MTE Consultants

**RE: Response to Zoning By-Law Amendment Application OZS24-015 Comments
115 Watson Parkway North, City of Guelph**

From: [Trevor Heywood](#)
To: [Jeff Lerch](#)
Cc: [David Cogliano](#); [Jonathan Rodger - Zelinka Priamo Ltd.](#); [Tatiana Guzman](#); [Dain Na](#); [Sarah Mainguy](#); [Ali Afrasiabi](#)
Subject: Re: GWHI - GRCA Comments - OZS24-015 - 115 Watson Parkway North
Date: March 25, 2025 3:09:05 PM
Attachments: [image.png](#)

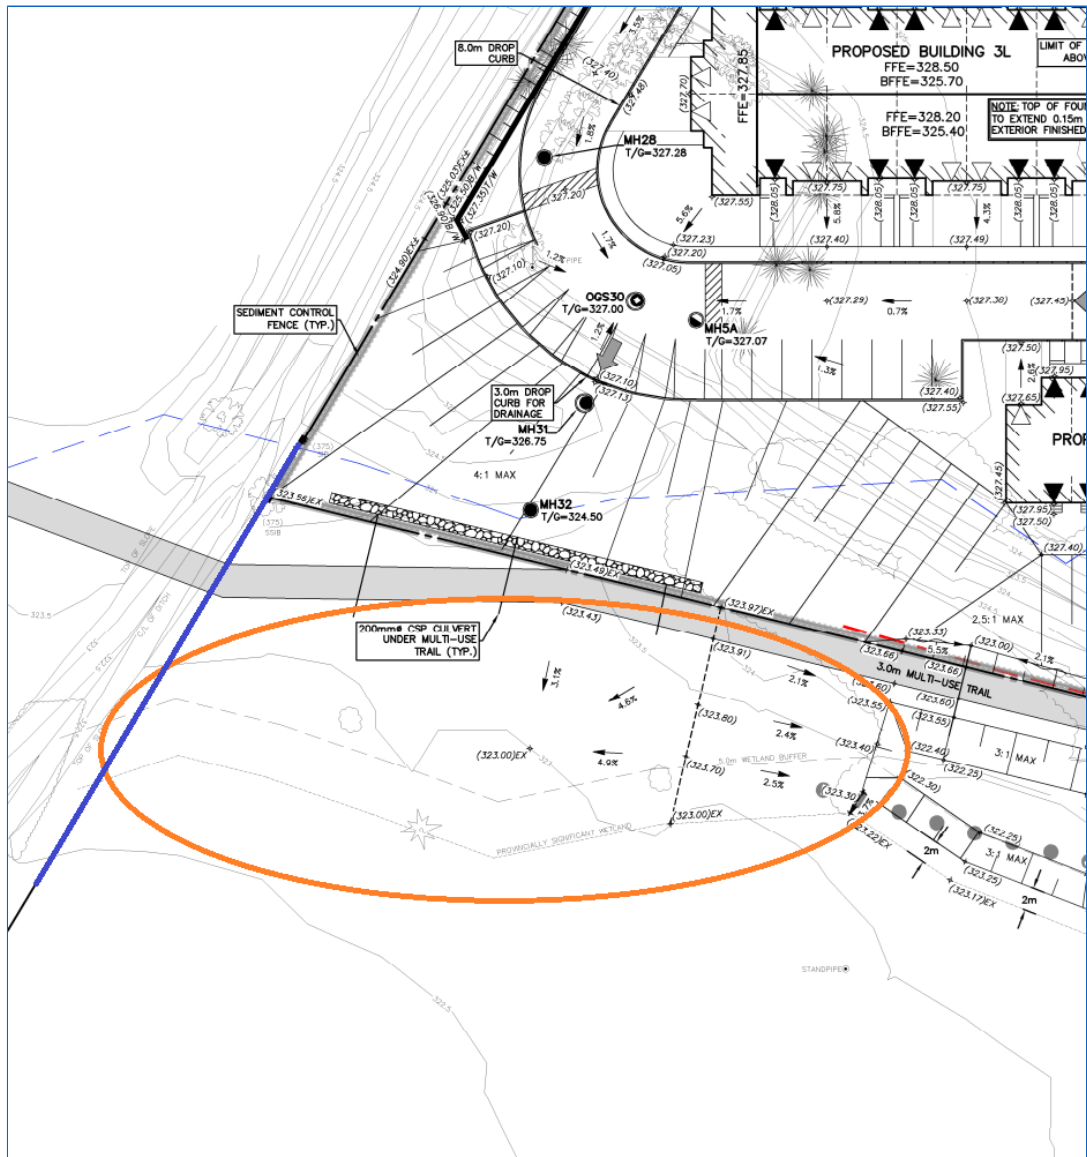
1. The amphibian pond location is acceptable, and so is the revised drawing. Please ensure this is kept in the formal resubmission drawings.
2. This is acceptable.
3. Received, thank you.
4. The vertical datum is not noted in the topo survey or grading plans. Confirming this by editing note 2 in the grading plans ("Existing topographical information provided by...") will be acceptable.
5. Received, thank you. As discussed, the floodline should be extended using topographic survey info.
 - a. I have looked at the topography at Watson Road and have no concerns with merely extending the illustrated floodline to the east property boundary (i.e. showing it within the roadway right-of-way is not required).
 - b. See image below; there seems to be enough topo information to extend it westerly (within the orange circle) to the boundary between two parts (blue line).
